BIOENGINEERING BUILDING DETAILED PROJECT PROGRAM ADDENDUM

VERIFICATION/RECONCILIATION PROCESS | VIVARIUM

UNIVERSITY OF CALIFORNIA, SANTA BARBARA

AUGUST 4, 2009

SITE PLAN

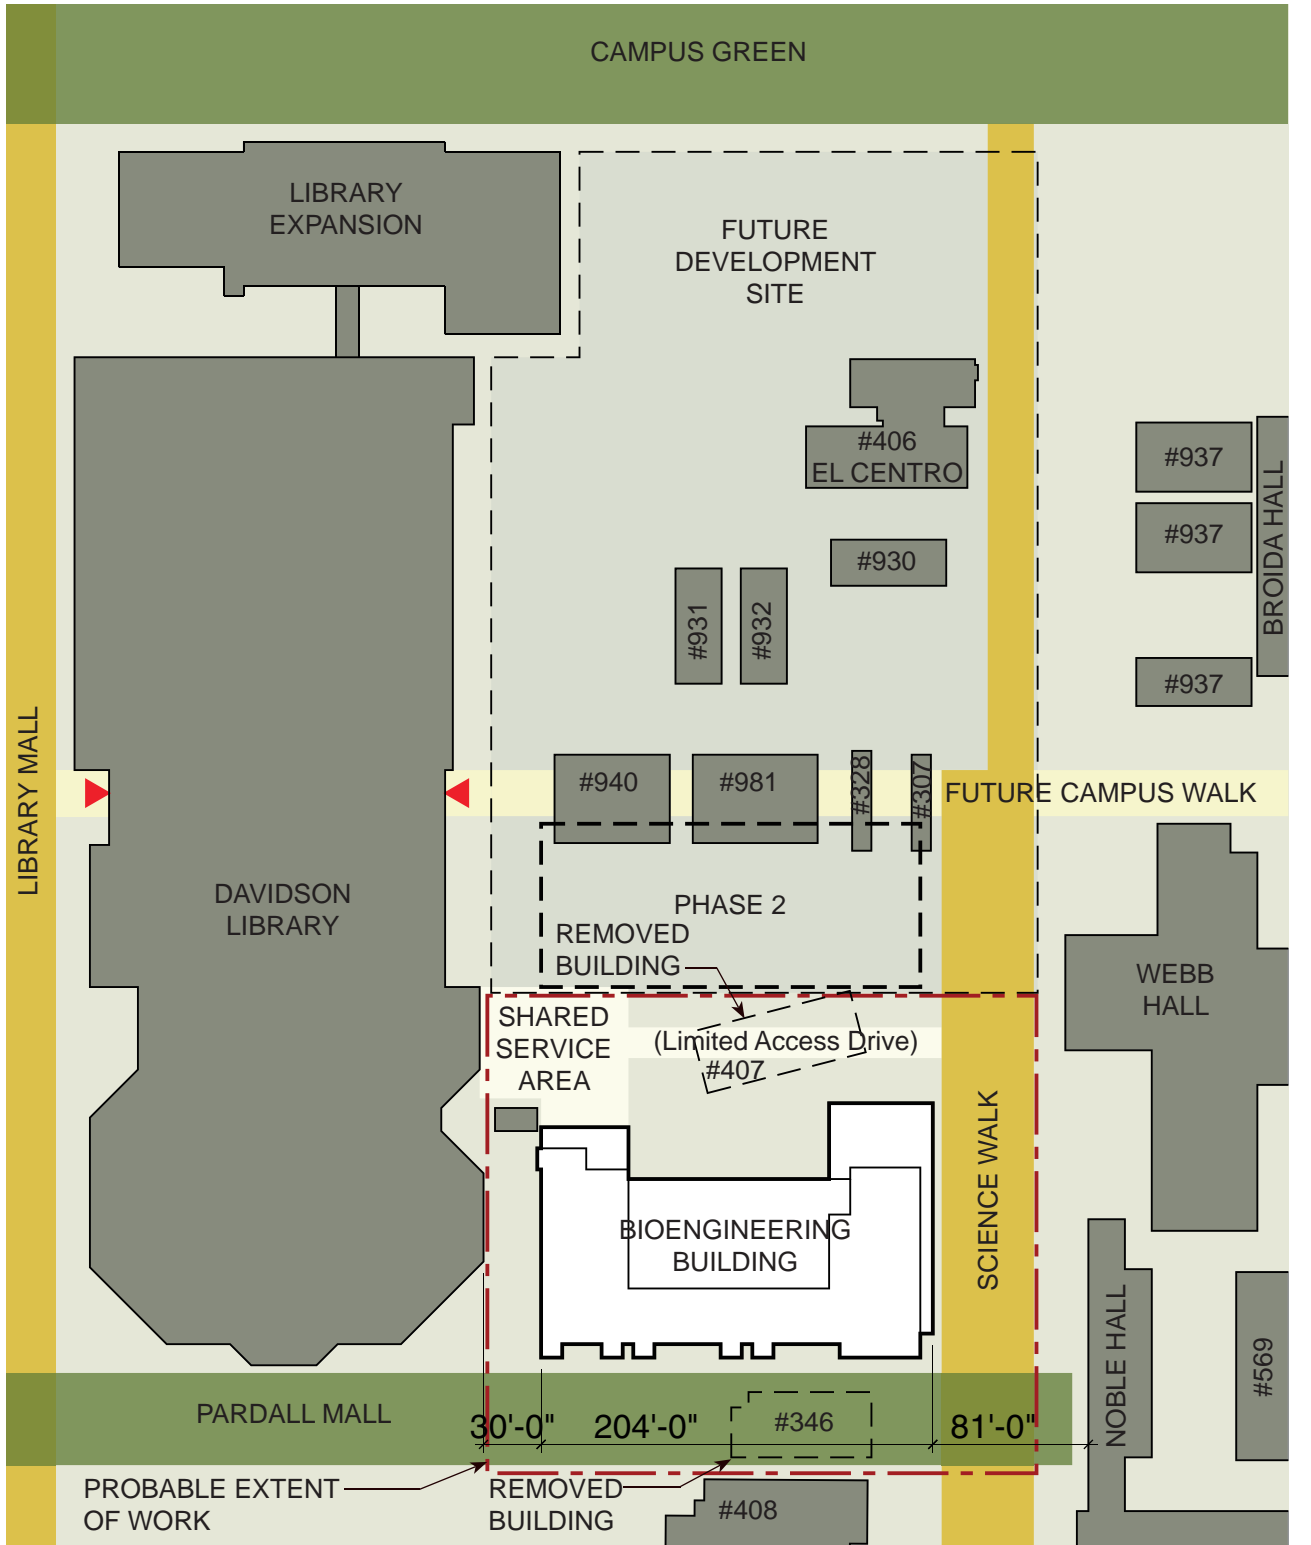
- page 5.1.4 The DPP states the site was selected to “provide more privacy for researchers.”
- The intent of this description is to indicate that the building, while being in the core of campus, is to be more secure and discrete by being located at the southernmost portion site study area as compared with a placement at the northern edge of the site adjoining the Campus Green. This is an acknowledgment of the sensitive nature of the research to be conducted in the building.

- page 5.1.7 Floor-to-floor heights are to be determined based on mechanical requirements, cost and façade design in a range from 15’-6” to 16’-0”.
- page 5.1.7 Updated Building Height Analysis and Stacking Diagram Sections have been relocated to
page 5.1.8 Section 6.2.0, Building Concept on pages 71 and 72.

- page 5.1.11 The Development Diagram describes a future Service Drive bordering the east edge of Davidson Library. This service zone includes the existing service area for the Library and potentially provides service access for the research facilities comprised of the Bioengineering Building and subsequent phases. This concept for service will require further study during the early design phases of the project.

FLOOR STACKING DIAGRAM

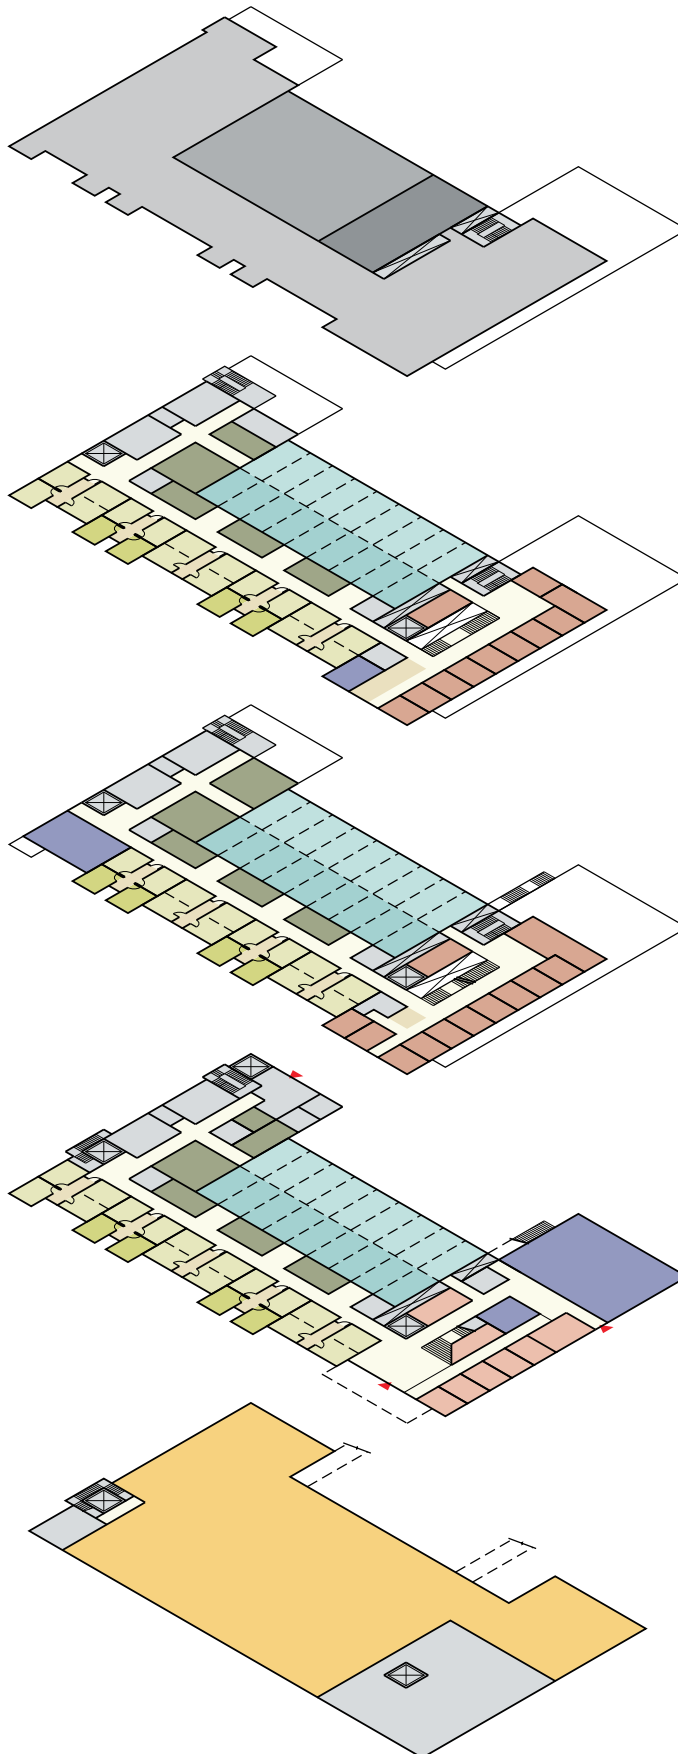
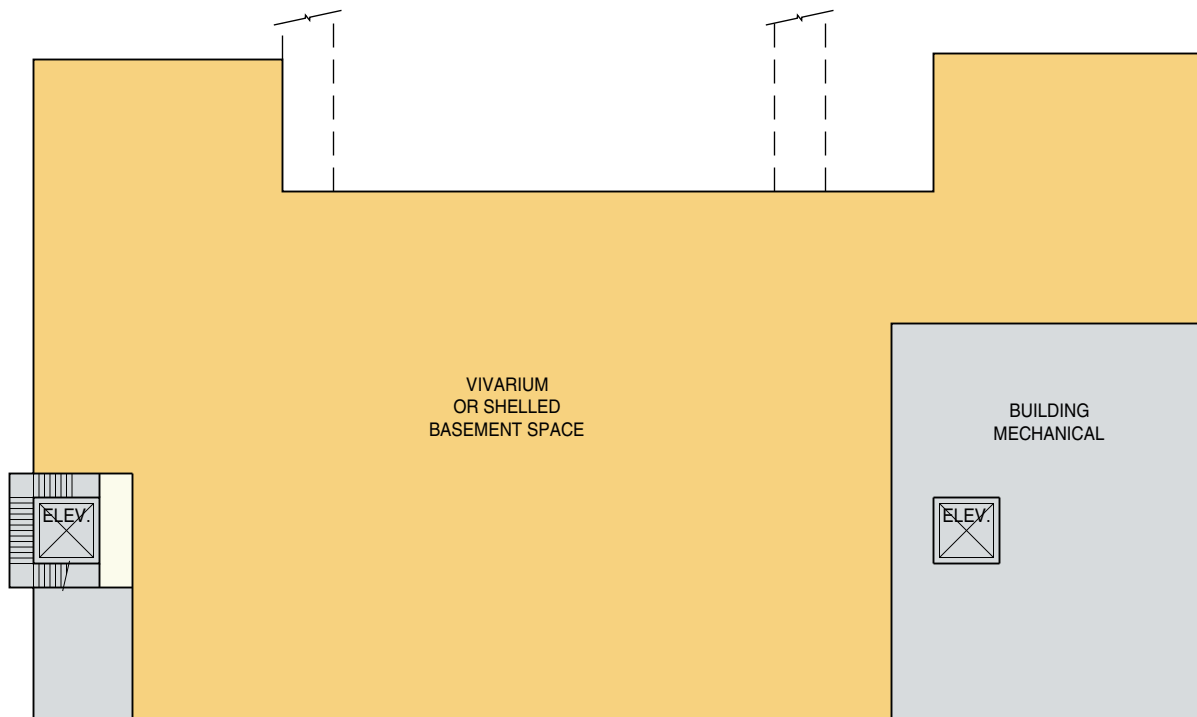
Building Concept Diagrams are revised as Concept 3B to match current Program. These include:

Site Analysis Diagram (updated Test to Fit Diagram)
Floor Planning Studies – Basement, Levels 1-3, Roof
Floor Stacking Diagram
